AGENDA

NCDENR Division of Waste Management And ReUse Technology, Inc.

Swift Creek Coal Combustion By-Product Project Nash County

February 6, 2003

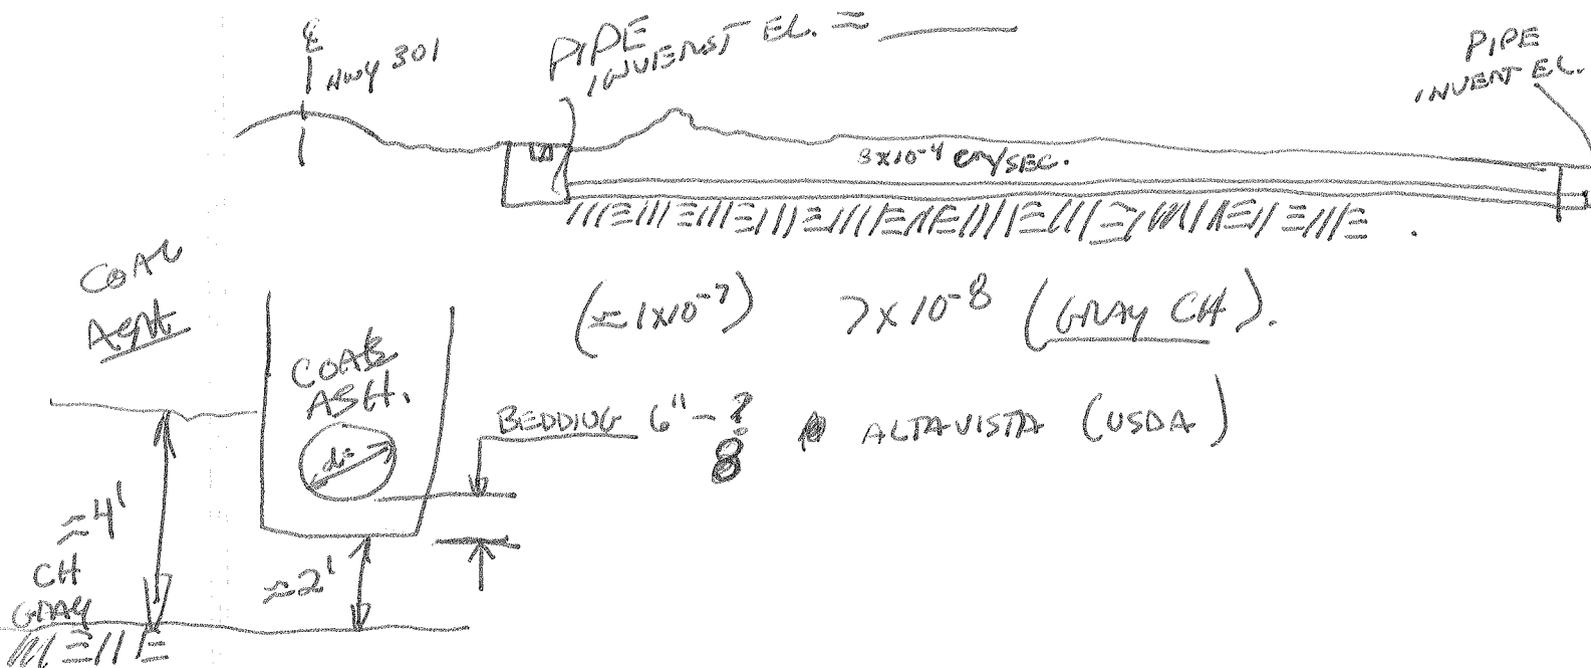
REMOVED ASA STOCKPILE ON-SITE TO PROJECT IN VA.
(100± TONS?)

NEW PIPE INSTALLED FOR SURFACE WATER CONVEYANCE
PARALLEL TO ROAD.
